**ITEM 12. DEVELOPMENT APPLICATION: 38 - 42 PIRRAMA ROAD
PYRMONT - REVY DEVELOPMENT**

FILE NO: D/2008/597

The proposal consists of the refurbishment of an existing heritage building (Building C) and envelope and concept approvals for two proposed future buildings (Building D & E).

Figure 9 - proposed roof

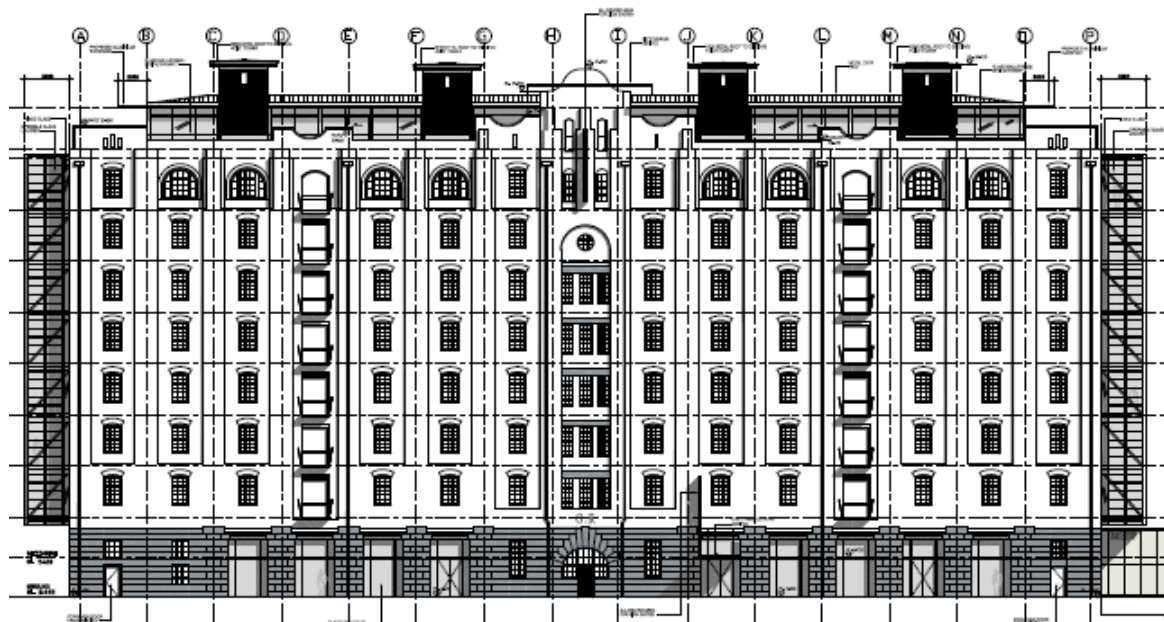
37. The proposed new roof addition to Building C is also generally supported. The new roof additions are to be setback 2 metres from the parapet line of the building and the height will be kept below the height of the lift/hoist structures protruding above the main roof to maintain the existing skyline. The roof is shown below.

Figure 10 - existing proposed balcony/ wintergarden

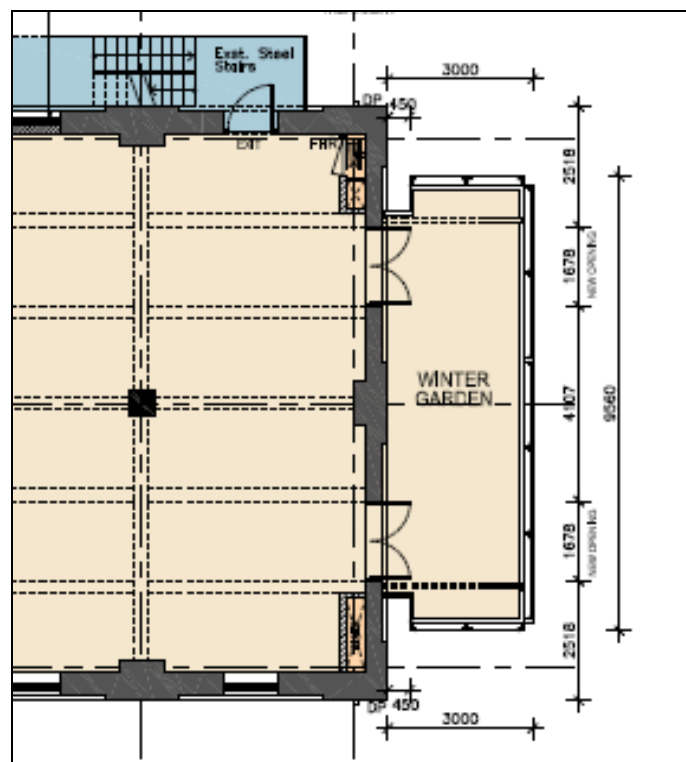
38. The size of the new balconies at either end of the building is not supported. The balconies are too heavy and need to be reduced in size and bulk. Conditions of consent recommend that the width of the balconies is reduced to 1800 mm. The existing proposed balcony is shown below.

- (ii) The security fence is to be removed;
- (iii) The projection of the balconies/ wintergardens should be reduced from 3000mm to 1800mm;
- (iv) The glazing of the wintergardens is to be frameless and clear. The design of the glazing is to allow for natural ventilation;
- (v) Any connection required between major areas of the mezzanine should be clearly interpreted as bridges;
- (vi) The internal stairs that connect the ground floor with the mezzanine levels stairs are to be rotated as required to avoid the removal of additional lengths of gantry.

Figure 12 – amended plan ground floor plan Building E

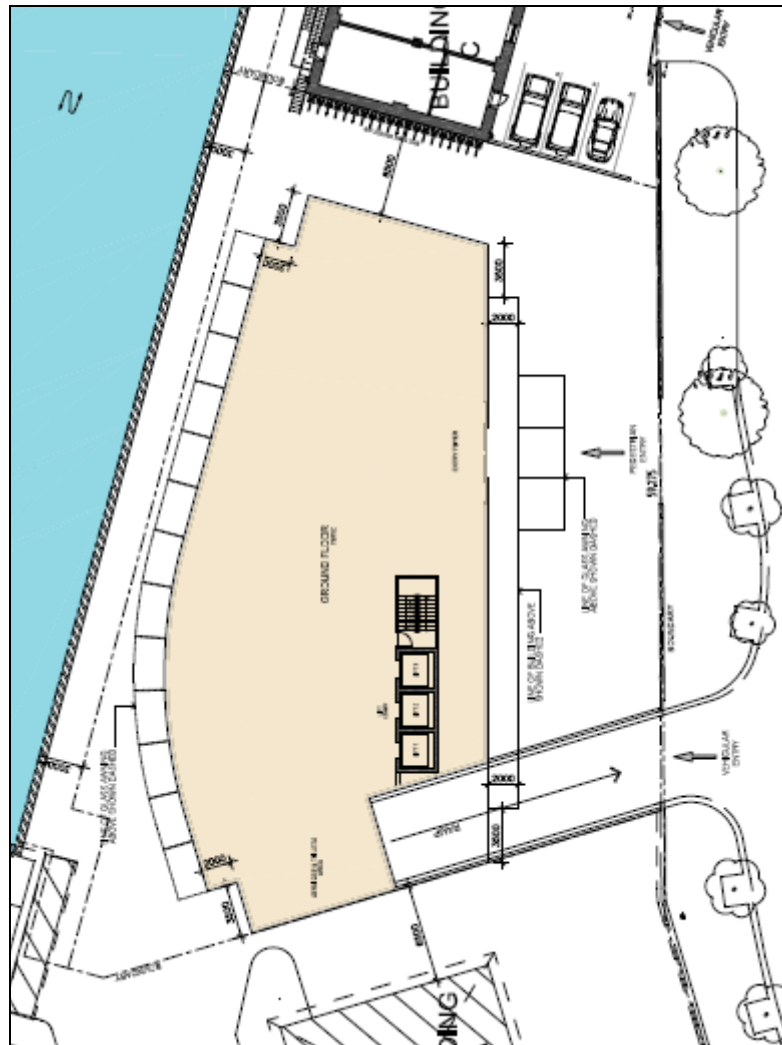
The applicant was requested to amend the proposal to address urban design issues, mainly related to the footprint of Building E (the two storey podium) located on Darling Island Road. The amended drawings were renotified. Seven submissions were received with these comments related to traffic.

- (i) To maintain the curvature formed between REVY A, B and C the setback of the building from Darling Island Road is to be increased by 1 metre;
- (ii) The footprint of the ground floor level curved frontage to Jones Bay is to be modified as follows:
 - a. Delete the recess in the northwest corner aligning this corner with the frontage of REVY C building.
 - b. Delete the recess in the south west corner by adjusting the curve to meet with the revised northwest corner alignment (the southwest corner of building E is to align with the north west corner of Building A);
